# Work Order ID 86679

Item Name: Crosstube Turning Detail

DRAWING NO. D212-664-147	TITLE CROSSTUBE ASS'Y (205 LOW FWD)	REV. B	DART AEROSPACE LTD ENGINEERING ORDER		D.E.O. NO. D212-664-147-B-1	SHEET NO. SHEET 1 OF 1	SCALE NTS
DRAWN <i>q</i>	CHECKED <i>ASS</i>	MFG. APPR. <i>VB</i>	APPROVED <i>WJ</i>		DE APPR. <i>WJ</i>		
DATE 11.07.15	DATE 11.07.20	DATE 11.07.21	DATE 11/07/21		DATE 11.07.21

REPLACE MAGNOBOND WITH PROSEAL.

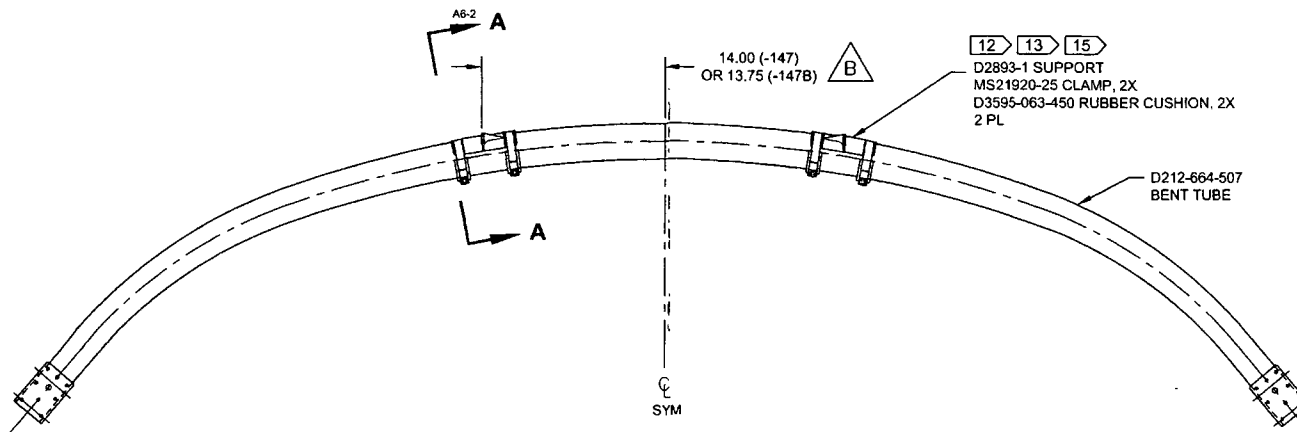
NOTE 12 & 15, SHEET 1 IS AMENDED AS FOLLOWS:

- 12) INSTALL D2893-1 SUPPORT USING 0.03" TO 0.06" THICK LAYER OF MAGNOBOND 6398 TO THE SURFACE OF D2893-1 THAT WILL BE IN CONTACT WITH THE CROSSTUBE PER QSI 015. LET CURE FOR 12 HOURS AFTER INSTALLATION AND PRIOR TO PACKAGING.
- 15) TORQUE CLAMPS 80 TO 100 IN-LB. ENSURE AT LEAST 1.5 THREADS SHOWING IN SAFETY AND THAT NUT HAS NOT BOTTOMED-OUT AFTER TORQUING.

- 12) TO INSTALL D2893-1 SUPPORT: ABRASE MATING SURFACE OF SUPPORT AND CROSSTUBE WITH 180-GRIT SANDPAPER AND REMOVE RESIDUE WITH MEK (OR EQUIVALENT). APPLY A 0.04" TO 0.07" THICK LAYER OF PROSEAL 890 CLASS B-2 (OR AMS-S-8802 CLASS B-2) SEALANT TO MATING SURFACE OF SUPPORT.
- 15) TORQUE CLAMPS 80 TO 100 IN-LB. ENSURE AT LEAST 1.5 THREADS SHOWING IN SAFETY AND THAT NUT HAS NOT BOTTOMED-OUT AFTER TORQUING. **PRIOR TO PACKAGING, RE-CHECK TORQUE ON CLAMPS AFTER PROSEAL 890 SEALANT HAS CURED FOR 72 HOURS.**
